**Dennis Tenement, Lincoln Street, c. 1820.**

1818  
 Abraham  
 Sheftall 1/2  
 321 York St. Savannah  
 6 Jun 17 43

EXISTING PORTICO N. ELEV. 1/2" = 1'

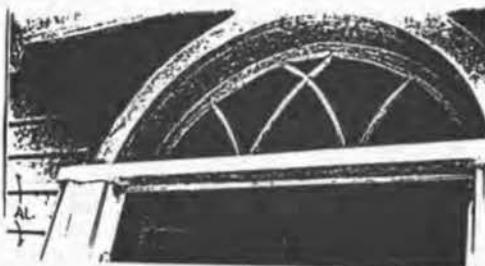
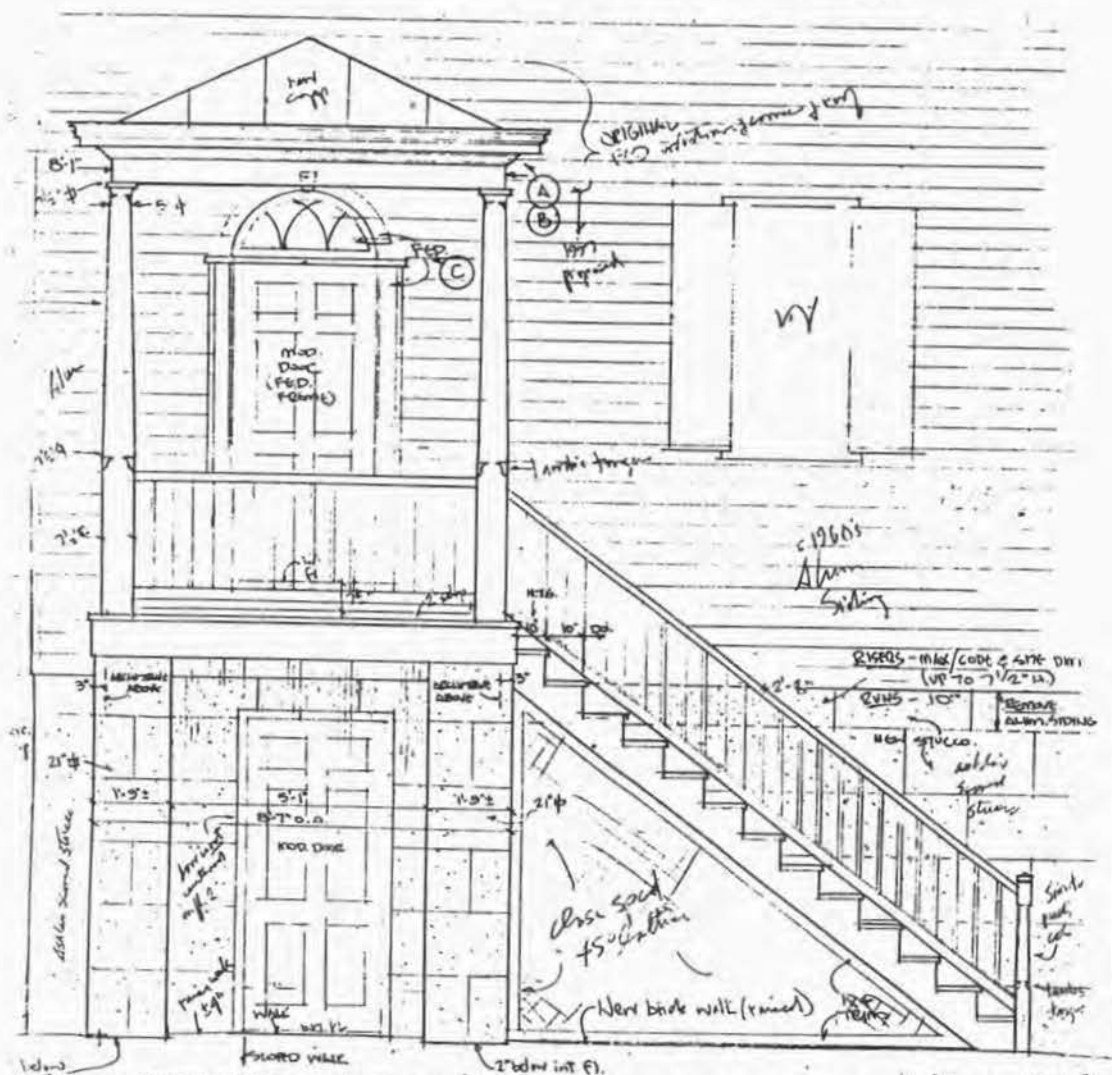
(LOTT + DREMER ARCH. DRWG.)  
 1. HSE MOVED TO YORK / LIBERTY ST. S.W. CORNER  
 REBUILT ABOUT 5', NEW STEPS & PORTICO PIECE  
 (ARCHITECTURE & ROOF OF PORTICO IS ORIG. FED. PER  
 PER SIGN - SOME FRAMING). NEW ENTRY FRAME &  
 ALUM. SIDING INSTALLED c. 1960's (?)

(bad proportions)

1. PORTICO FL. = 7 1/2" BELOW ENTRY FL. (VERSUS 8 1/4" NOW) = SUBJECT TO ENCO. OFFICIAL APPROVAL.
2. FL. OF PORTICO SLIPS 2" TO FRONT LIP (= 9 1/4" BELOW INT. FL.).
3. REVERSE WALK TO ENCO W/ LEVEL 1 FL. AT LOWER ENTRY (H.C. ACCESS). HAS 4 1/2" STEP NOW.
4. " " " 2" BELOW " " " " " PILES & STOPS = ABOUT 4" - 5" HIGHER THAN NOW.
5. MAKE PILES ± 10" φ (VERSUS 14" NOW). MAKES PILES LOOK SHORTER.
6. MAKE STOPS AS STEEP AS CODE ALLOWS (= 7 1/2" RISE, 10" RUN) - VERIFY AT SITE. 7 3/4" MAX/CODE
7. INSTALL FWD. TYPE COLS. & BALUSTRADES
8. " CLOSE-SPACED (2 1/4" φ HOLES) PAINTED LATTICE UNDER STOPS.
9. " ANTI-SLIP-SCORED PAINTED STUCCO ON BRICK FINED. WALLS & PILES
10. " 6" FENCE AT 12' ± 2' OFF

NOTE!  
 SHUTTERS  
 PILES ± 10"

ELEV  
 Main ent

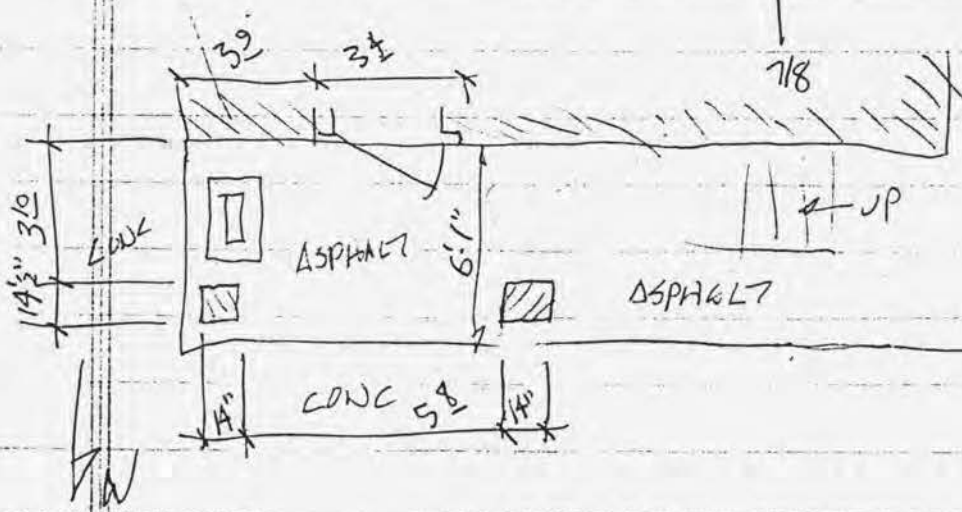
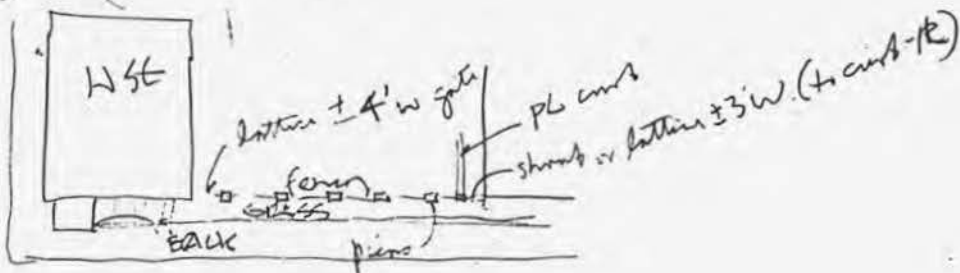
1. Revise elev of bread store around  
 Replace awning - replace <sup>mass.</sup> in less garish colors  
 (similar design but calmer colors, w/ sign on front of awning, "BAKERY")

2. Portico also sim. to Belle Mont (ML)  
 Fence piers " " " " ( " )

Portico steps as step as curb allows  
 Step down 7 1/2" out of base down to  
 portico fl.
